UNITED STATES
DEPARTMENT OF THE INTERIOR
BUREAU OF LAND MANAGEMENT

SUNDRY NOTICES AND REPORTS ON WELLS
Do not use this form for proposals to drill or to re-enter an abandoned well. Use form 3160-3 (APD) for such proposals.

7. If Unit or CA/Agreement, Name and/or No.
Well Name and No.
EL ZORRO FREMONT FEDERAL 01

9. API Well No.
30-025-33147-00-S1

Proposed P&A

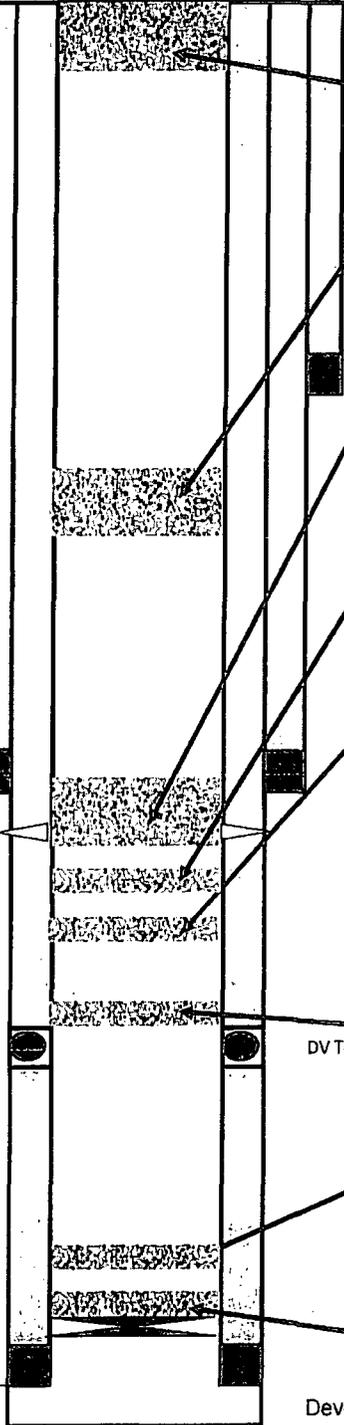
- ? Spot a ~~8 1/2~~ SX (686 ft) CLS H cement plug 11474 - 11924 ft. WOC & Tag Plug. This will plug the Mississippian, Morrow, & Atoka.
- ? Spot a 25 SX (213 ft) CLS H cement plug 9437 ft - 9650 ft. WOC & Tag Plug. This will plug the Bough "C".
- ? Spot a 25 SX (213 ft) CLS H cement plug 8767 ft - 8980 ft. WOC & Tag Plug. This will plug the Wolfcamp.
- ? Spot a 25 SX (213 ft) CLS H cement plug 7507 ft - 7720 ft. WOC & Tag Plug. This will plug the Abo.
- ? Perforate at 4237 ft. Attempt to establish Circulation. Spot a 72 SX (253 ft) CLS C cement plug 3984 ft - 4237 ft. WOC & Tag Plug. This will plug the 8.625 inch casing shoe and San Anders.
- ? Spot a 35 SX (122 ft) CLS C cement plug 2148 ft - 2270 ft. WOC & Tag Plug. This will plug the Anhydrite.
- ? Spot a 10 SX (~~35~~⁶⁰ ft) CLS C cement plug 0 ft - ~~35~~⁶⁰ ft. WOC & Tag Plug. This will plug the Top.

Records show 5 1/2
circ. Perf(?)

→ Spot 25 SX plug
from 2860 - 2730
woc Tag. (Yates)
